# Access Compliance Report

## Public Rights-of-Way

### (Curb Ramps)

Intersection ID: 21239	Main Street: CAMBRIDGE BELTWAY DR	Cross Street: S TRYON ST	Location: SE
ADA ID: 2C9C6C86C021	Ramp Type: Perp	Initial Pass/Fail: Fail	Overall Compliance: No
Severity Score: 13.75			
Codes/Mitigation Info/Possible Solution		Field Measurements/Component Compliance

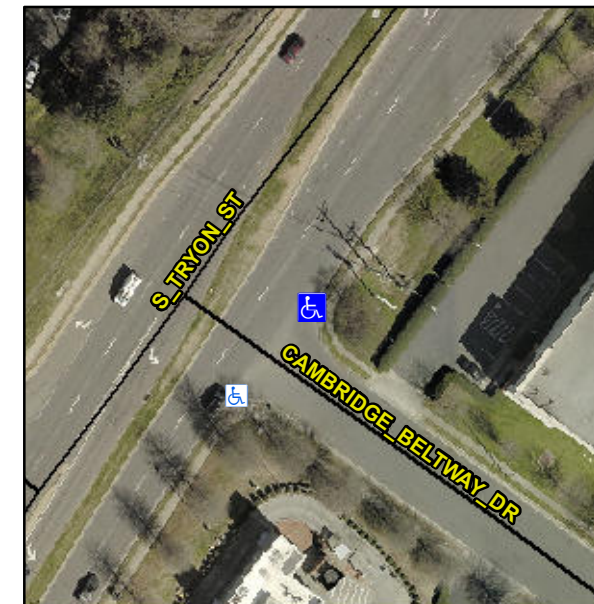
**Not Found, R304.2.2**

Compliance	Description	Data	Compliance	Description	Data
N/A	Ramp Length (in)	90.0	No	Ramp Slope (%)	8.9
Yes	Ramp Width (in)	49.0	Yes	Ramp XSlope (%)	3.0
N/A	Flare Type LT	N/A	N/A	Flare Type RT	N/A
N/A	Flare Slope LT (%)	N/A	N/A	Flare Slope RT (%)	N/A
N/A	Flare Traversable LT?	N/A	N/A	Flare Traversable RT?	N/A
N/A	Landing Length (in)	N/A	N/A	DWS Provided?	N/A
N/A	Landing Width (in)	N/A	N/A	DWS Contrast?	N/A
N/A	Landing Slope (%)	N/A	N/A	DWS Length (in)	N/A
N/A	Landing X Slope (%)	N/A	N/A	DWS Full Width?	N/A
N/A	Landing Curb? (Y/N)	N/A	N/A	DWS Offset (in)	N/A
N/A	Shared Landing?	N/A			
N/A	Gutter Ponding?	N/A	N/A	Gutter Slope (%)	N/A
N/A	Gutter Lip Ht (in)	N/A	N/A	Gutter X Slope (%)	N/A
N/A	Painted X Walk1?	No	N/A	Painted X Walk2?	N/A
	X Walk 1 Direction	To SW		X Walk 2 Direction	N/A
N/A	X Walk 1 Width (in)	N/A	N/A	X Walk 2 Width (in)	N/A
	X Walk 1 Slope (%)	3.0		X Walk 2 Slope (%)	N/A
	X Walk 1 X Slope (%)	6.7		X Walk 2 X Slope (%)	N/A

**Remove & Replace Entire Ramp.**
